REMARKS

Claims 1-19, 21-24 and 26 as amended, and new claims 27-28 are pending for the Examiner's review and consideration. Claims 20 and 25 are cancelled herein without prejudice to Applicants' rights to file one or more continuing applications directed to this or other unclaimed subject matter. Claims 1 and 21 were amended to include one of the features recited in claim 2, *i.e.*, that the spacing arrangement is operatively associated with the support member and a wall or wall member to provide sufficient spacing between the support member or support surface and the wall or wall member (*See also* Specification at page 3, lines 23-26; page 14, lines 32-33; page 15, lines 1-4 and 25-29; and page 23, lines 14-20). Claim 2 was amended to remove this recited feature. Claim 17 was rewritten in independent form. Claim 26 was amended to depend from claim 21. New claims 27 and 28 recite a preferred embodiment where the spacing arrangement positions the support member about 0.125 inches to 2 inches from the wall or wall member (*See, e.g.*, Specification at page 16, lines 8-10). No new matter has been introduced by any of the amendments or new claims herein, such that entry of the claims

FIG. 5

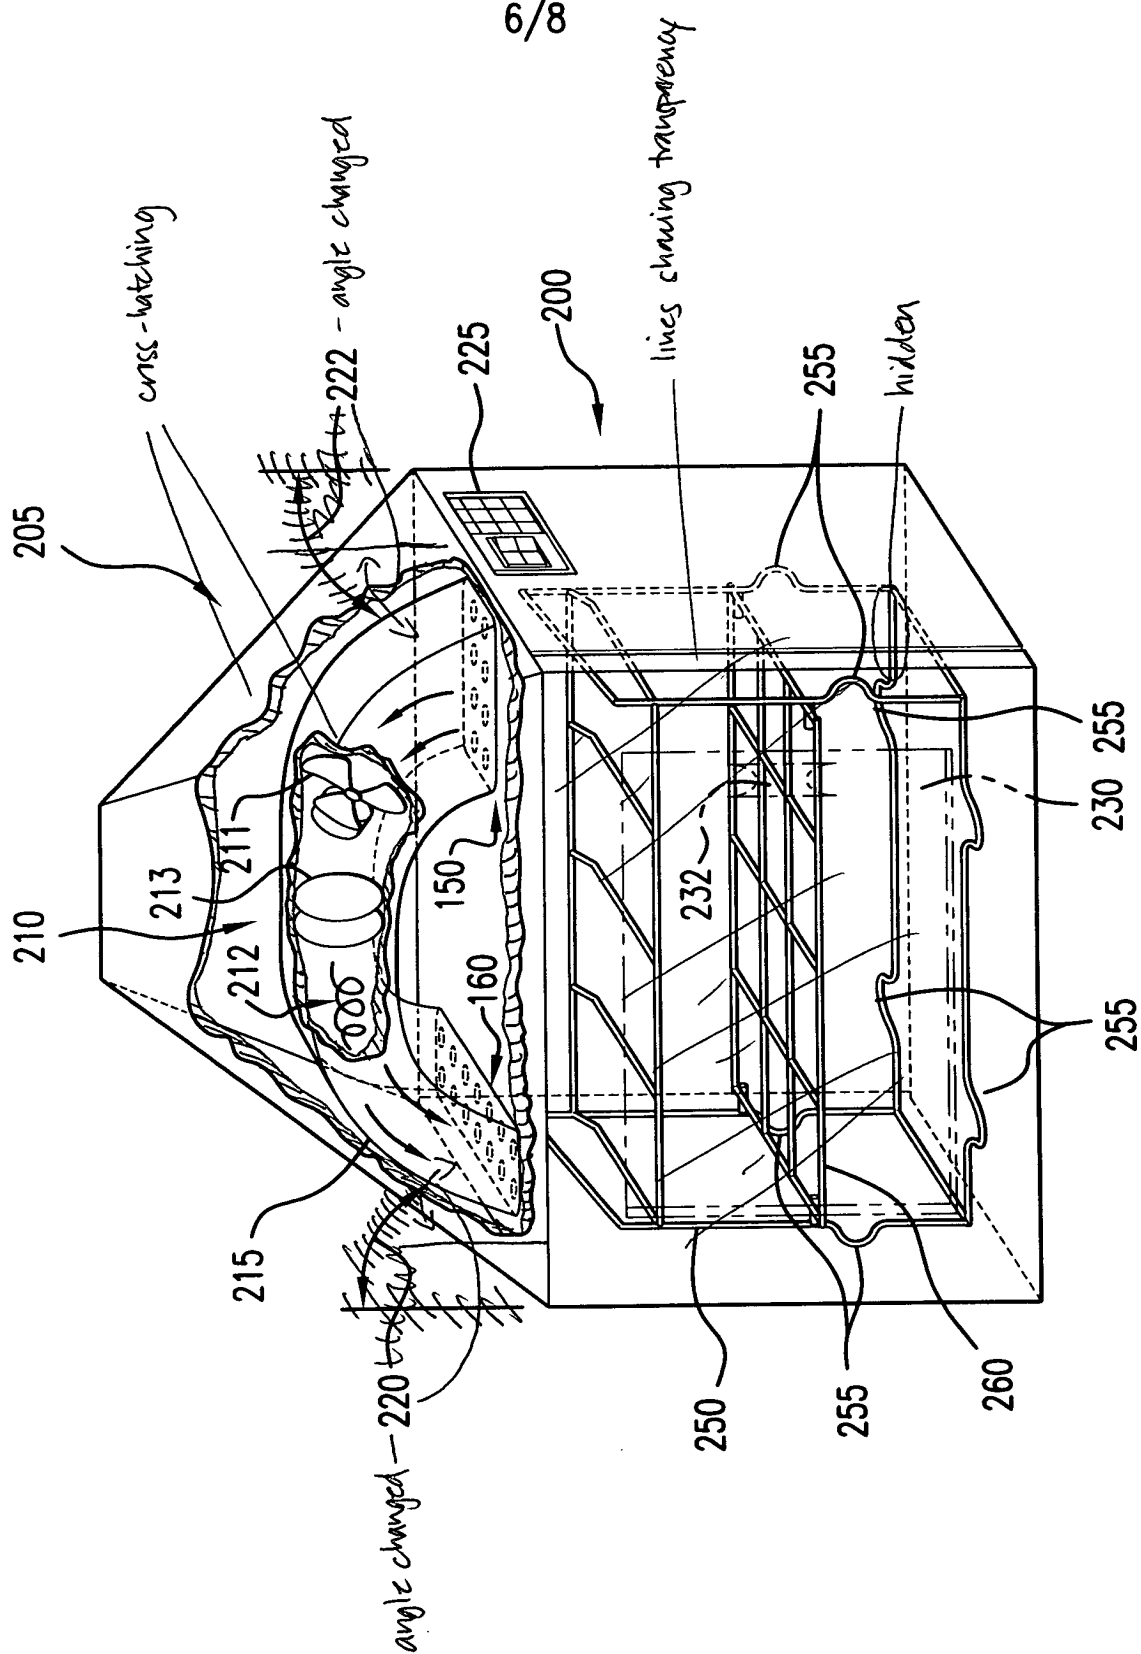
The drawings were objected to on page 2 of the Office Action because Figure 5 allegedly does not use the proper cross-hatching. Figure 5 has been amended to include proper cross-hatching. Figure 5 has also been amended as follows. First, the angles 220 and 222 have been amended to refer to the angle from the heating system to the adjacent vertical wall member, as is stated in the Specification at page 33, lines 26-29. The bottom right portion of the support member 250 has also been amended to clarify that it is hidden from view. Finally, lines showing the transparency of at least one wall have been added, the optional, but preferable transparency of the wall noted in the Specification at page 11, lines 31-32. A copy of FIG. 5 with redlining showing these changes, along with a revised FIG. 5 incorporating the changes, are submitted herewith. Accordingly, Applicants respectfully request that the objection to the drawings be reconsidered and withdrawn.
